中華電力有限公司
CLP Power Hong Kong Limited

Code of Practice 101 for Distribution Substation Design (COP101)
Update No. 4/2019 – New and Revised COP101 Drawings

Document:	COP101 Version 14
Effective Date:	10 December 2019
Summary of Change:	New and revised COP101 drawings are listed below and attached. 1. Revision of drawing - T-COP-10250-D-E33-0102-03-E-A (Concrete wall or steel supporting structure added to optimise cable routing.) 2. Revision of drawing - T-COP-10250-D-E33-0102-04-E-A (Concrete wall or steel supporting structure added to optimise cable routing.)) 3. Revision of drawing - T-COP-10250-D-E33-0103-16-E-A (Dimension of wicket door added.) 4. Revision of drawing - T-COP-10250-D-E33-0103-17-E-A (Dimension of wicket door added.) 5. Revision of drawing - T-COP-10250-D-E33-0103-18-E-A (Dimension of wicket door added.) 6. Revision of drawing - T-COP-10250-D-E33-0103-19-E-A (Dimension of wicket door added.) 7. Revision of drawing – T-COP-10250-D-E33-0103-29-B-A (Outlet of temporary supply cables updated.) 8. New drawing – T-COP-10250-D-E33-0103-40-A (Typical details of eyebolt Installation for L.V. board)

DRG. NO. T/COP/10250/D/E33/0102/03/E/A

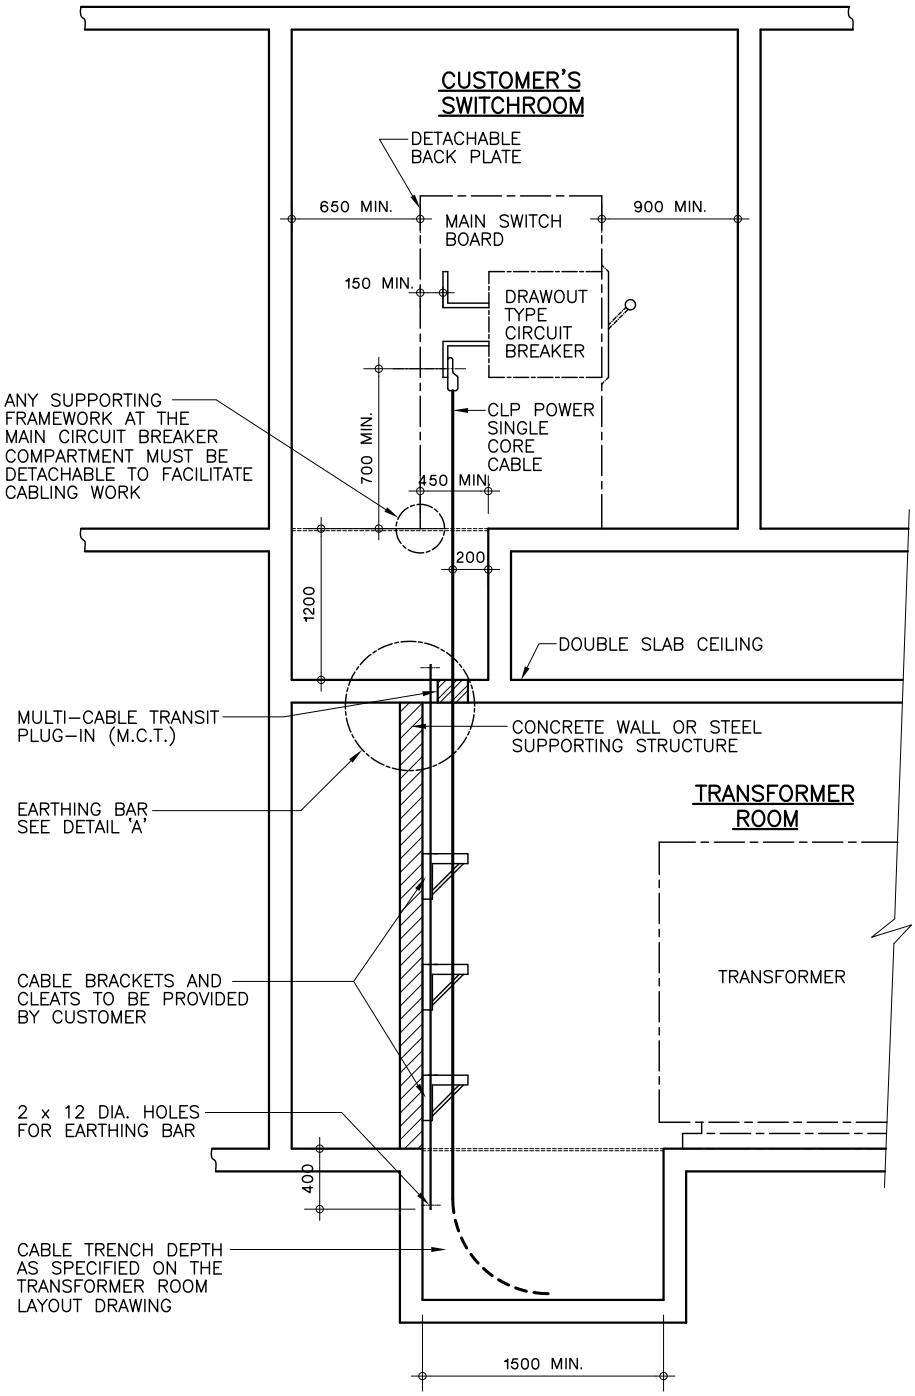
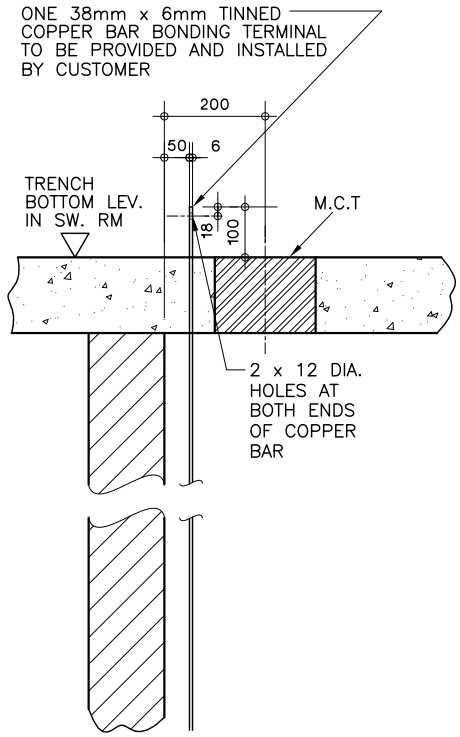
E	CONCRETE WALL OR STEEL SUPPORTING STRUCTURE ADDED TO OPTIMISE CABLE ROUTING
D	CABLE TRENCH AND FACILITY FOR CUSTOMER MAIN SWITCHROOM UPDATED
C	DIMENSION OF CABLE TRENCH ADDED AND DOUBLE SLAB HEIGHT CHANGED
B	DOUBLE SLAB CEILING ADDED
A	NOTE 2 ADDED

DRG. NO. T/COP/10250/D/E33/0102/04/E/A

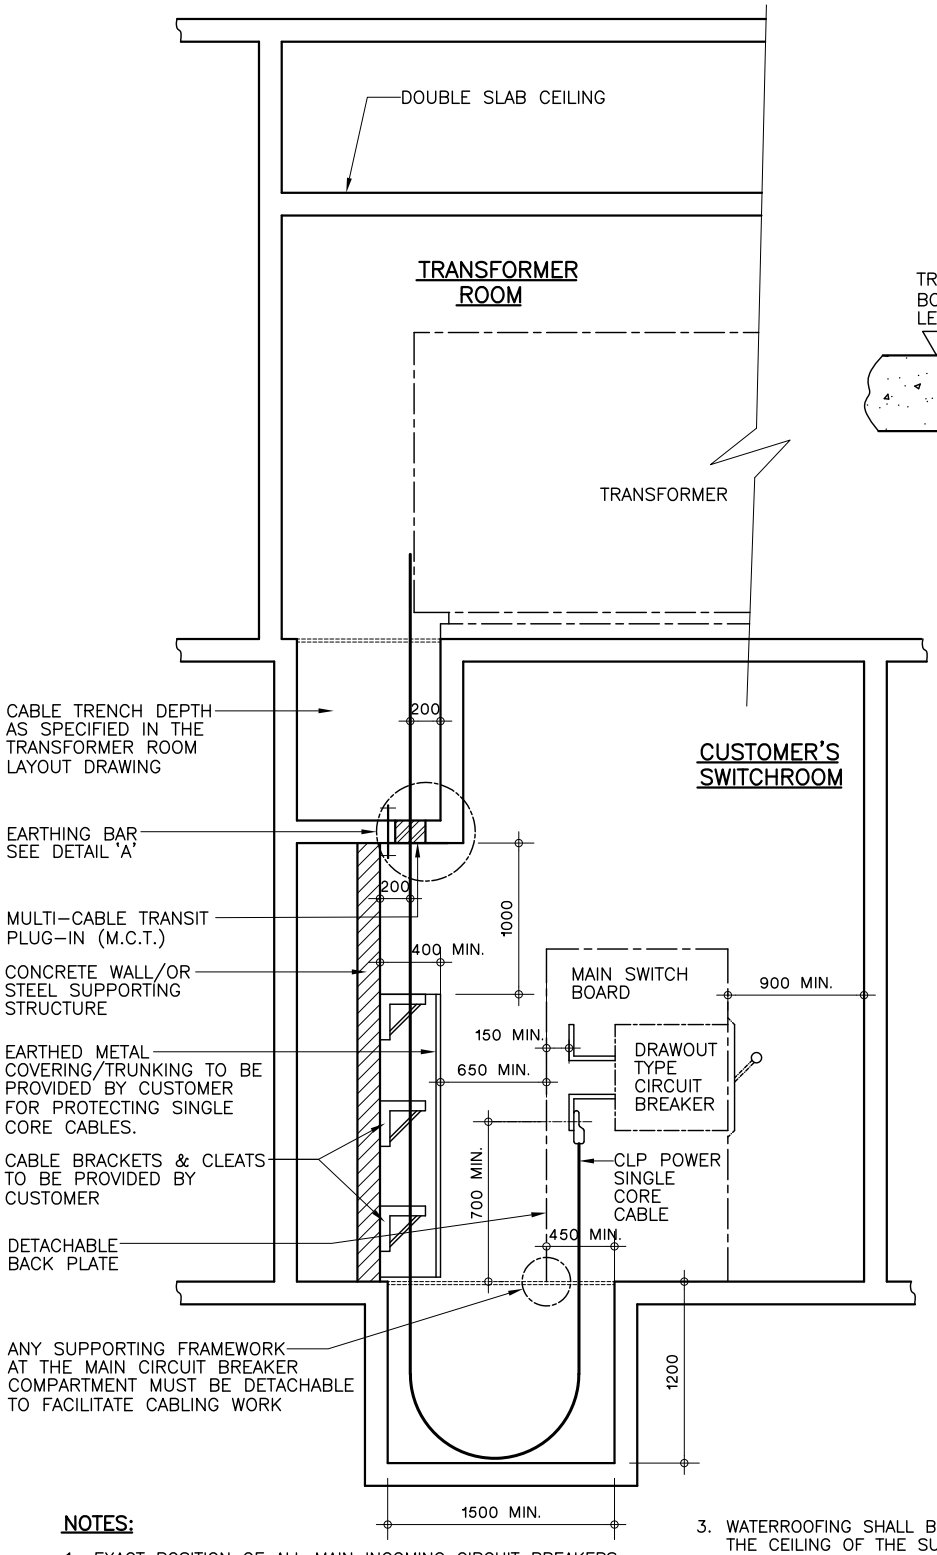
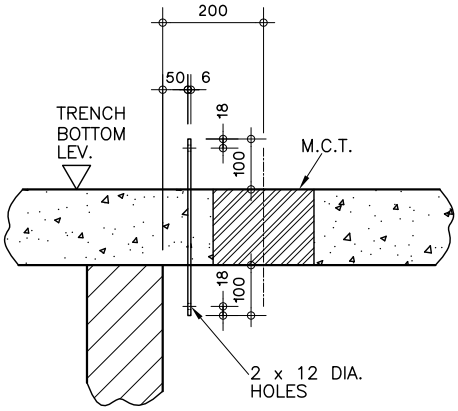
C	DIMENSION OF CABLE TRENCH ADDED AND DOUBLE SLAB HEIGHT CHANGED	D	CABLE TRENCH AND FACILITY FOR CUSTOMER MAIN SWITCHROOM UPDATED.	E	CONCRETE WALL OR STEEL SUPPORTING STRUCTURE ADDED TO OPTIMISE CABLE ROUTING

DRG. NO. T/COP/10250/D/E33/0103/16/E/A

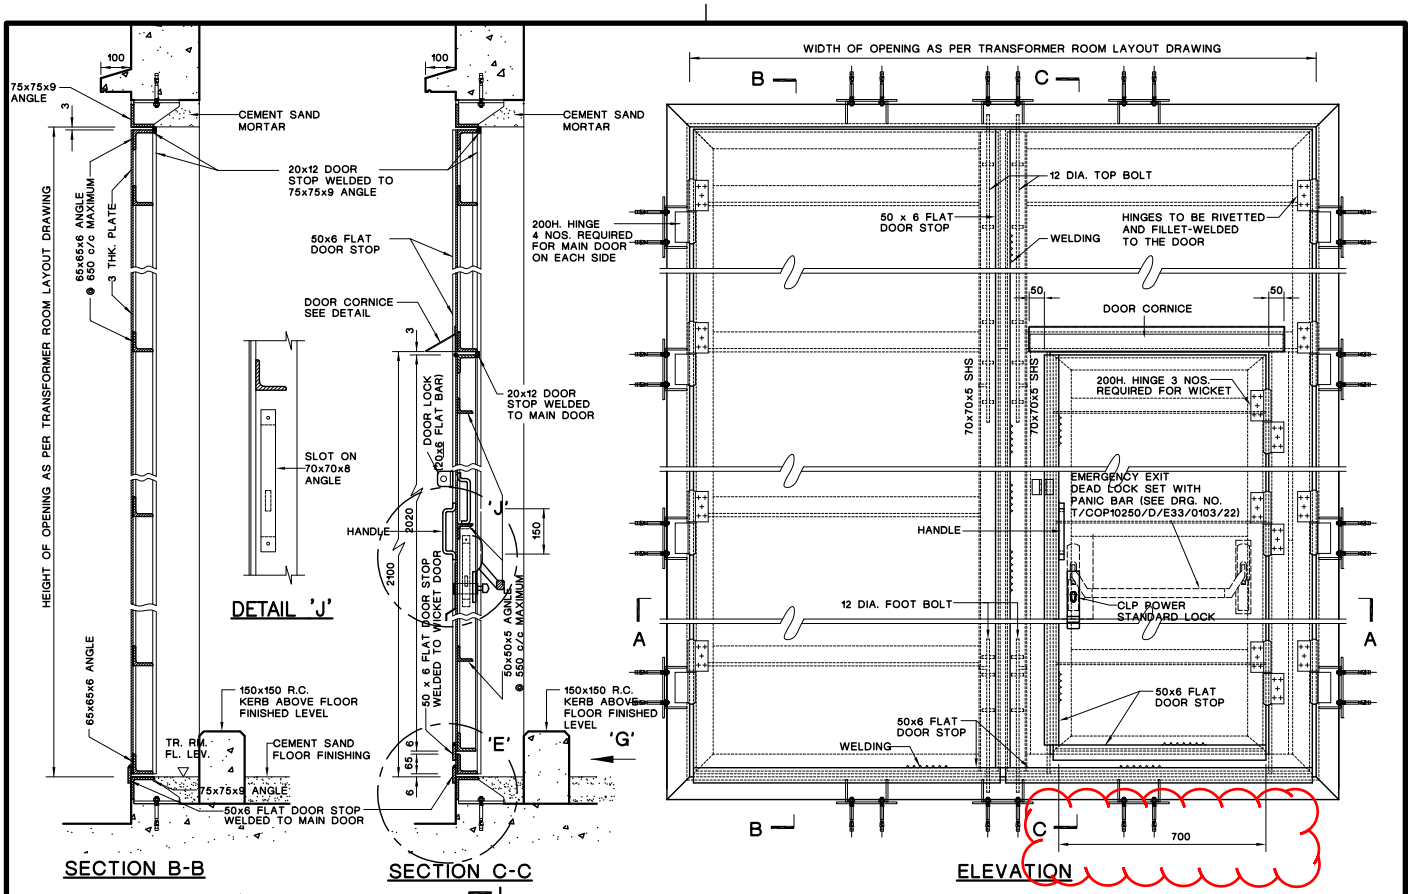
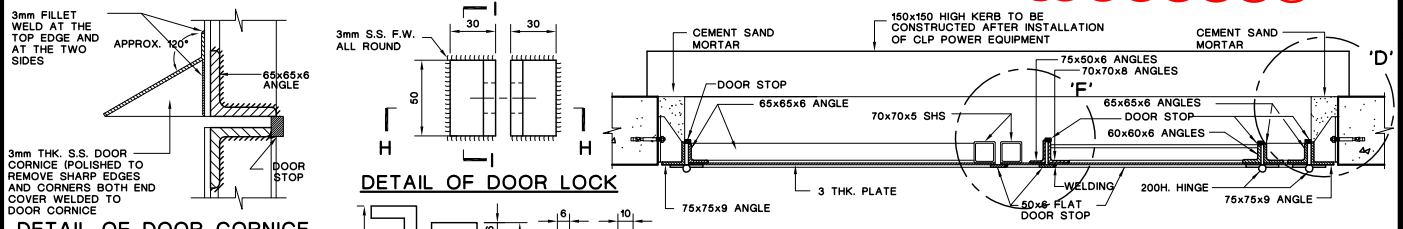
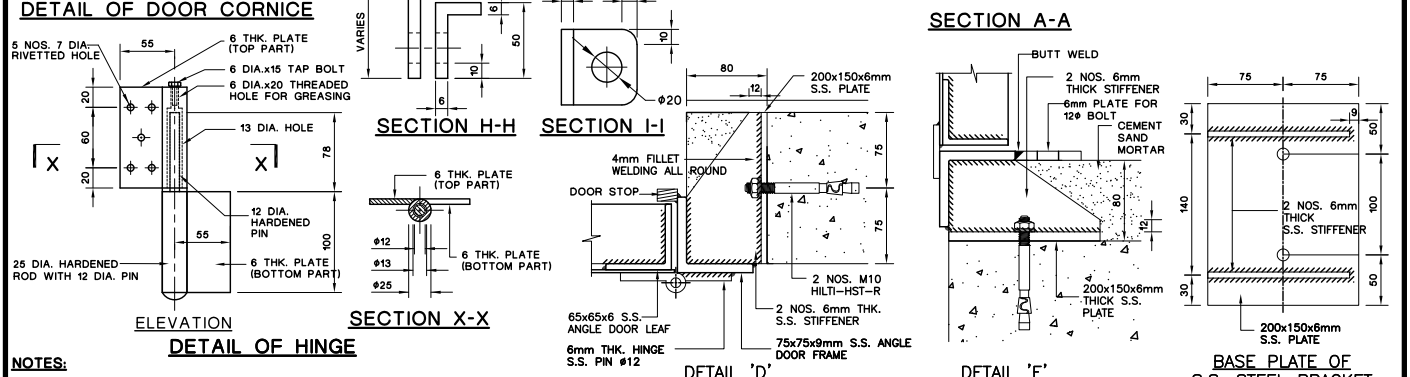
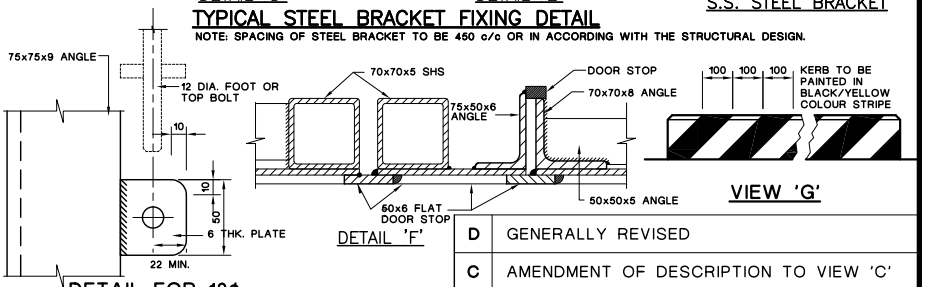
D	GENERALLY REVISED
C	AMENDMENT OF DESCRIPTION TO VIEW 'C'
E	DIMENSION ADDED

DRG. NO. T COP 10250 D E33 0103 17 E A

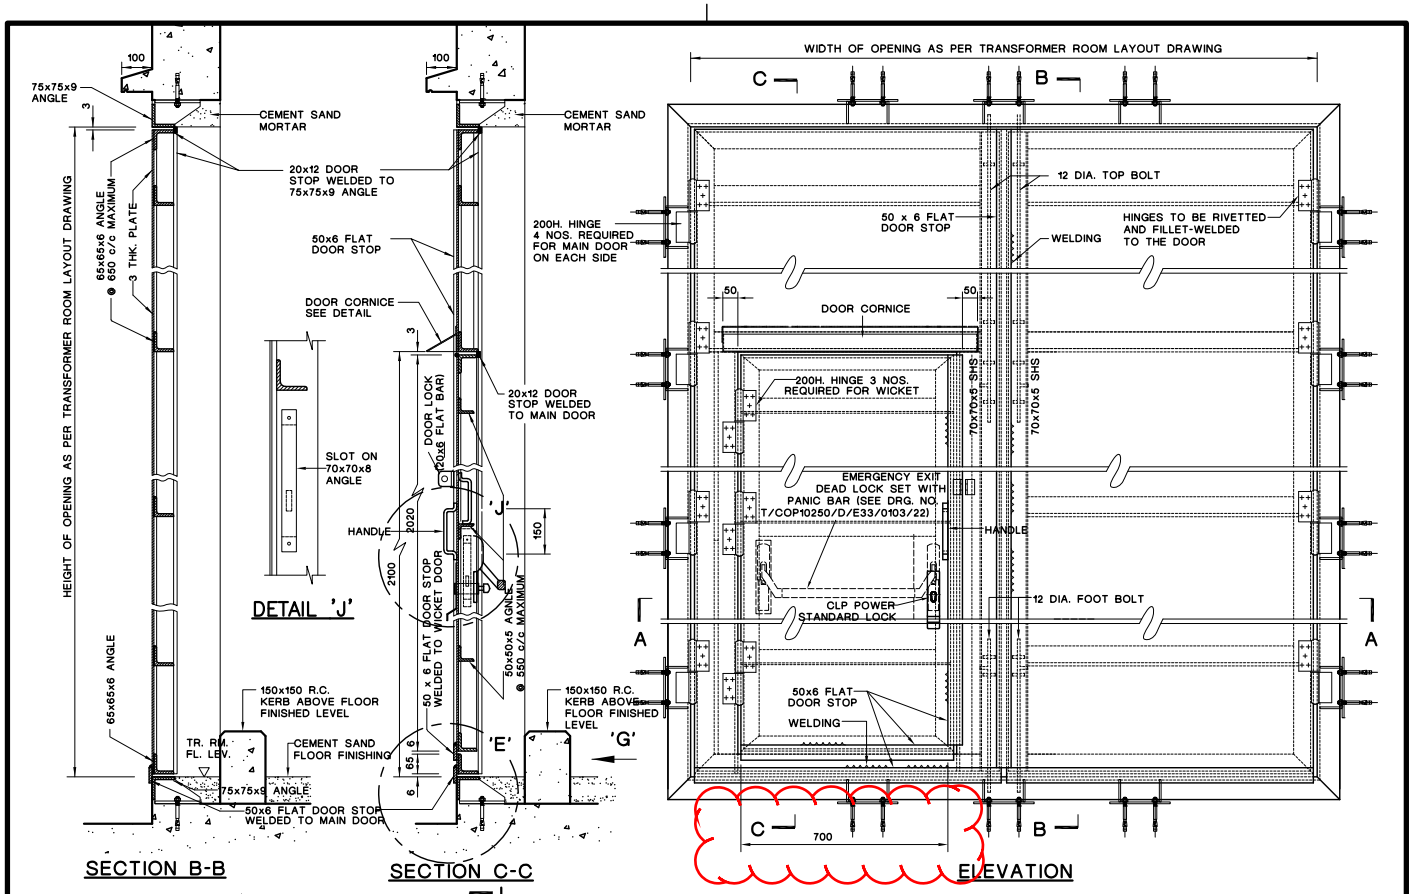
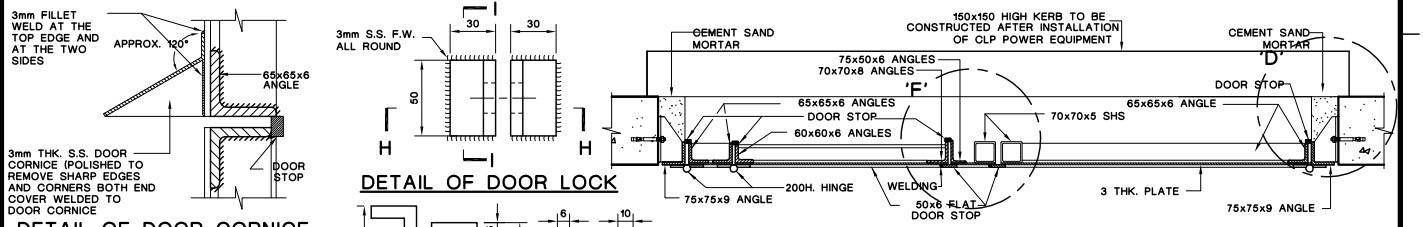
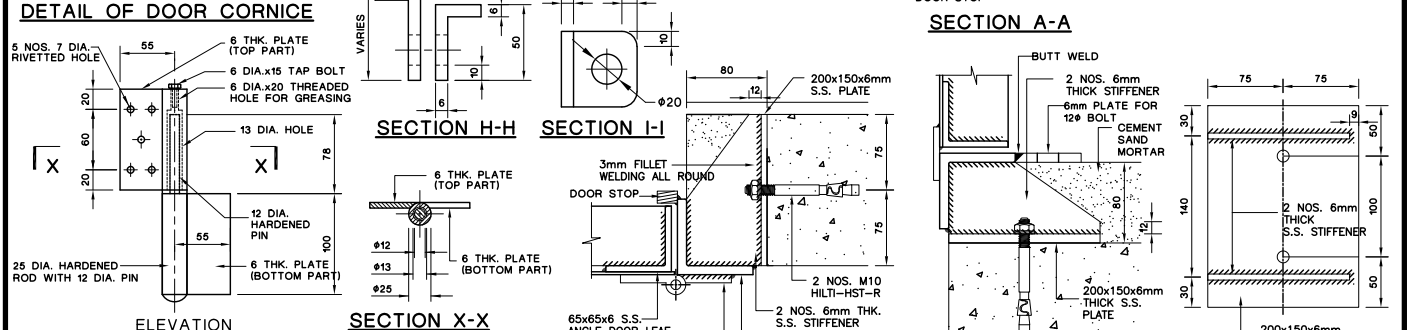
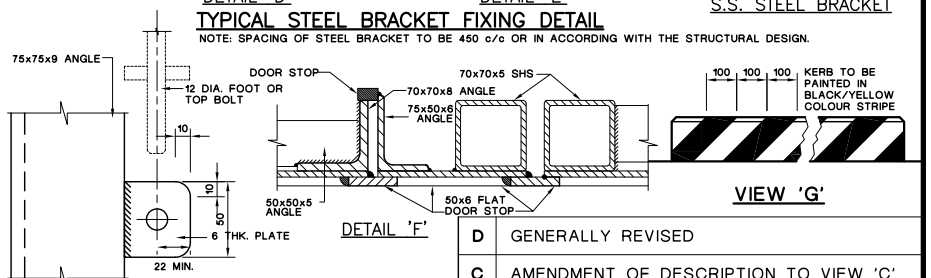
D	GENERALLY REVISED
C	AMENDMENT OF DESCRIPTION TO VIEW 'C'
E	DIMENSION ADDED

DRG. NO. T COP 10250 D E33 0103 18 E A

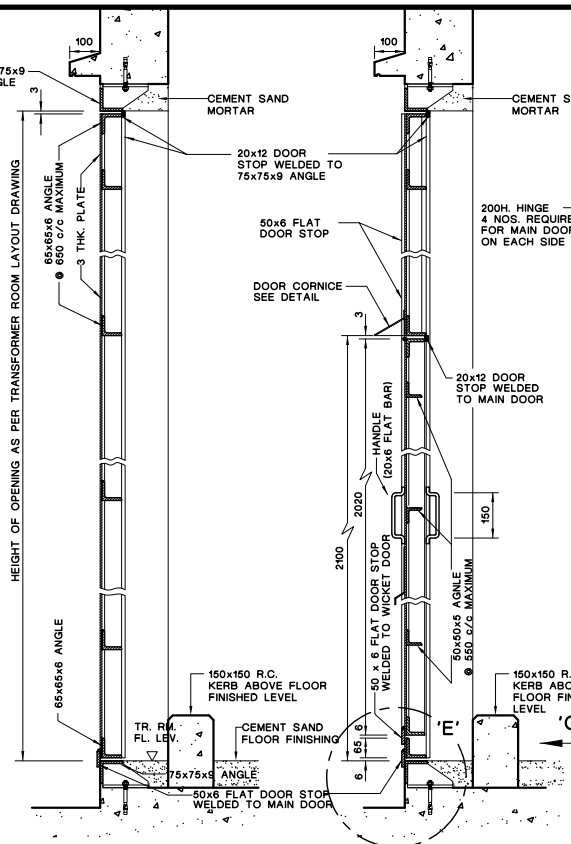
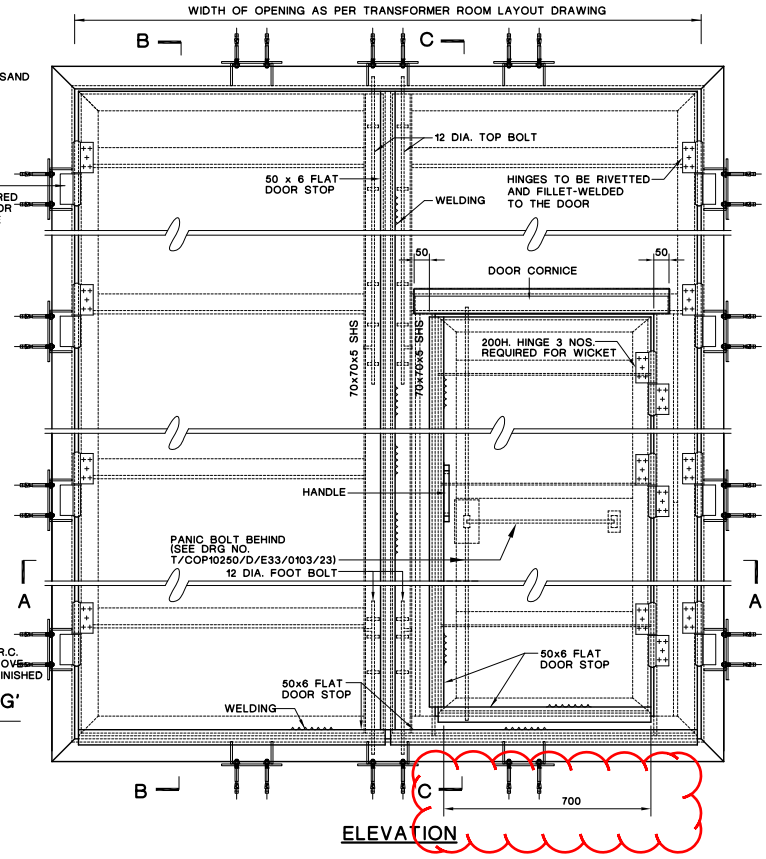
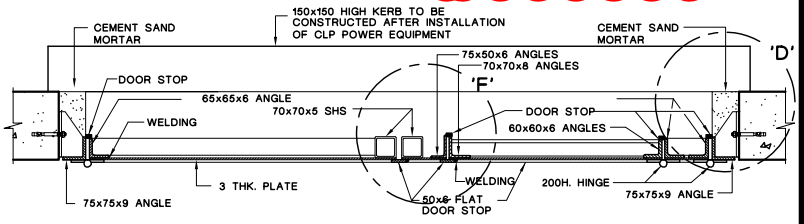
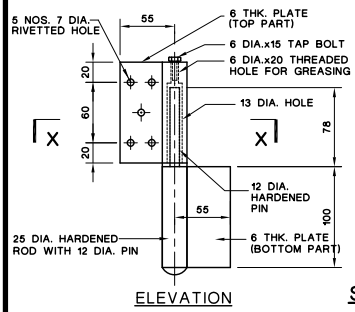
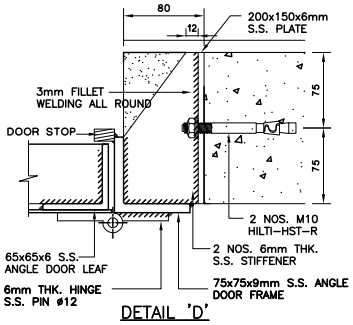
D	GENERALLY REVISED
C	AMENDMENT OF DESCRIPTION TO VIEW 'C'
E	DIMENSION ADDED
